ATTACHMENT 2
PROPOSED CHANGES

**FORT ST. VRAIN NUCLEAR GENERATING STATION
ADMINISTRATIVE AND DEPARTMENTAL MANAGEMENT ORGANIZATION CHART**

ATTACHMENT 3
SIGNIFICANT HAZARDS
CONSIDERATION

FIGURE 7. 1 - 1

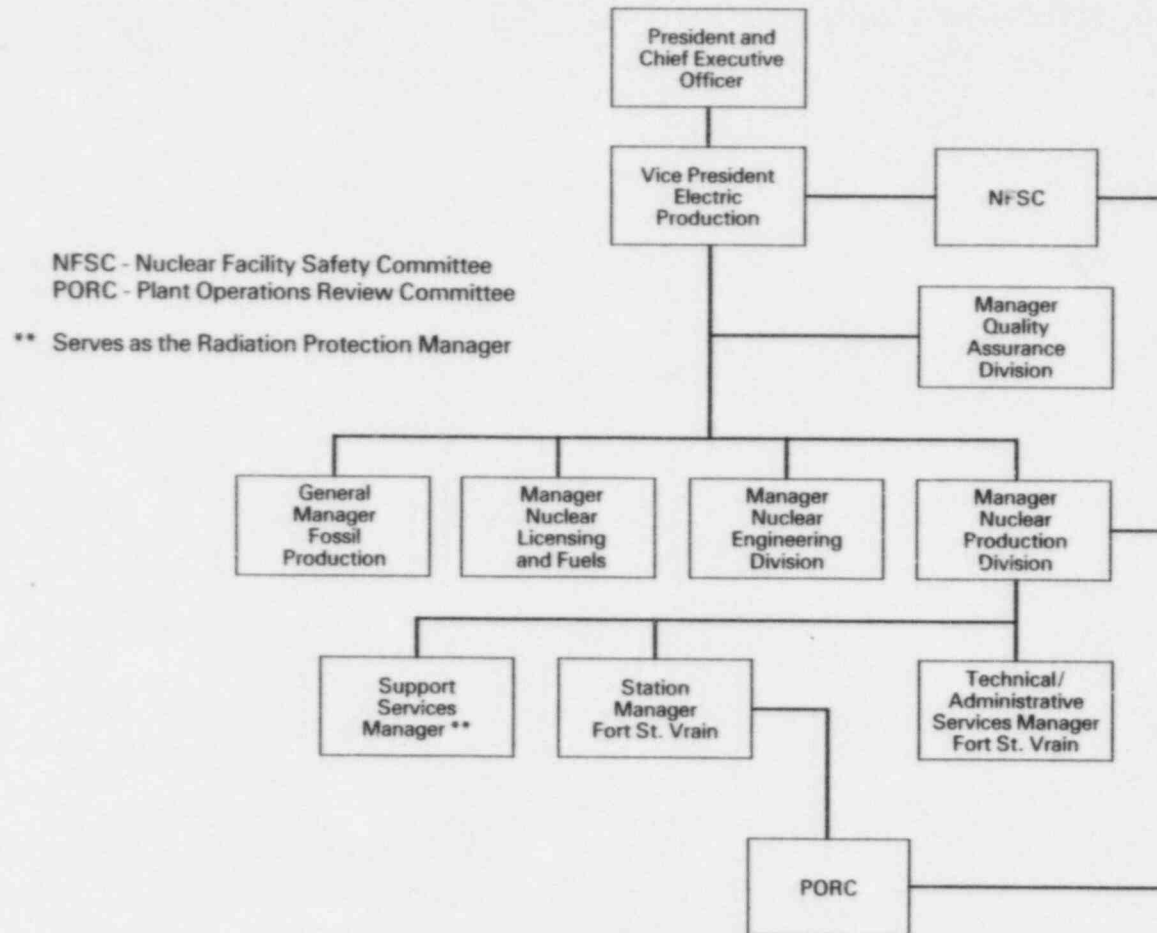
Since the proposed changes to Section 7.1 of the Fort St. Vrain Technical Specifications are administrative in nature, no significant safety hazards considerations are involved. Section 7.7 is also administrative in nature, and no significant safety hazards considerations are associated with this new Technical Specification.
